SERVICE BULLETIN

Replacement of oil filter for ROTAX® Engine Type 912 i, 912 and 914 (Series)

ATA System: 79-00-00 Lubrication system

Fig. 1
Oil filter

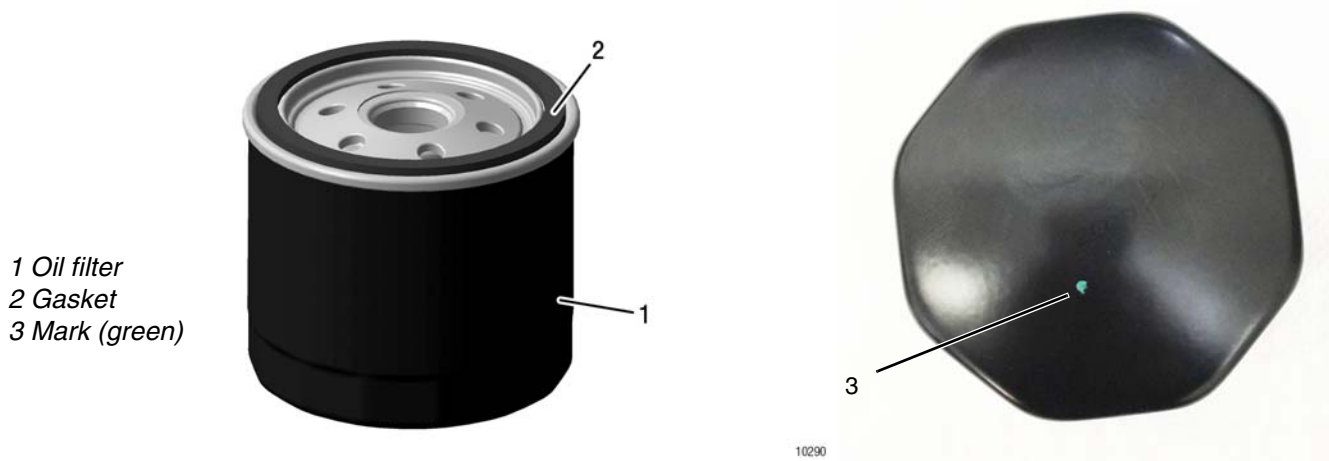
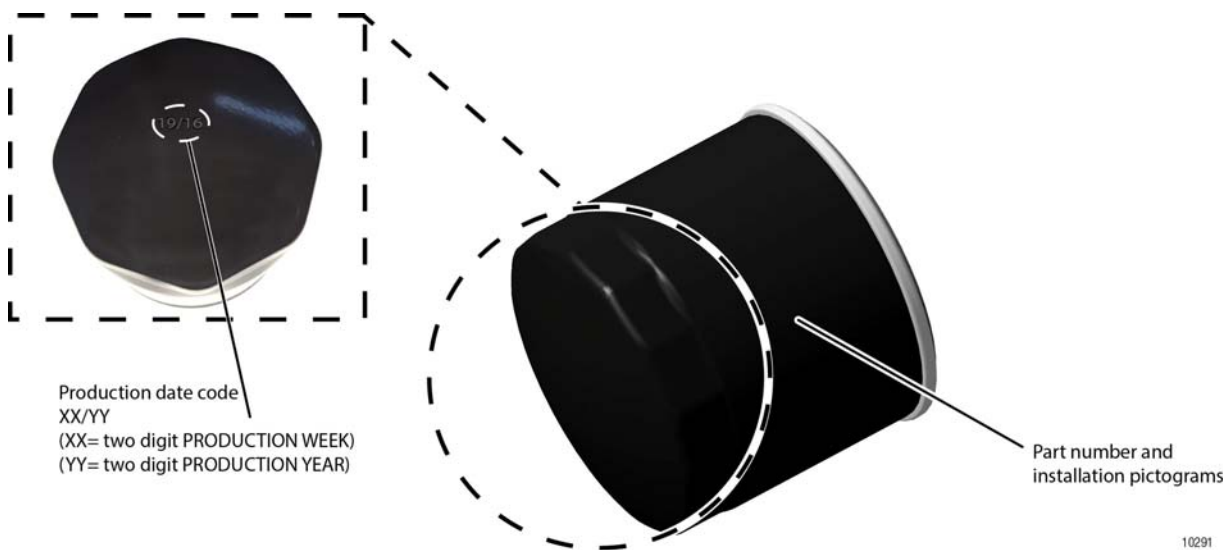
The above engines have been fitted by the manufacturer with an oil filter part no. 825016 with a production date code 10/17 up to 38/17 and have no green mark see Fig. 1).

All engines are affected, which have been equipped with an oil filter part no. 825016 (with a production date code from 10/17 up to 38/17) during engine repair, maintenance or general overhaul as of June 8th, 2017 to October 31st, 2017 and have no green mark. see Fig. 1).

Due to deviations in the manufacturing process of the oil filter's gasket, cracks in the gasket may have occurred. In rare cases, these deficiencies might lead to oil leakage in the area of the oil filter gasket.

Step	Procedure
1	Check the engine logbook and maintenance documentation or shipping documents to see if this Service Bulletin has already been accomplished.
2	<p>Check whether the affected oil filter shows a green mark on the crown of oil filter (as illustrated in Fig. 1) (same area as production date code).</p> <ul style="list-style-type: none"> - green mark is present: this oil filter is OK as it has already been tested by the supplier and can be used even though the production date code is from 10/17 to 38/17. No further actions are required. - green mark NOT present: this oil filter is NOT OK, please follow the instructions in section 3.2). <p>NOTE: If production date code is not easy to read, use a proper means of light (e.g. flashlight directed at a proper angle onto the oil filter crown etc.) for better visibility of the coding imprint.</p>

Step	Procedure
1	Remove the affected oil filter according to the Maintenance Manual Line.
2	Install the new oil filter according to the Maintenance Manual Line.

Step	Procedure
1	Quarantine and/or remove affected filters from your inventory. Mark as unserviceable and return F.O.B. to your ROTAX® Authorized Distributor or their independent Service Centers.
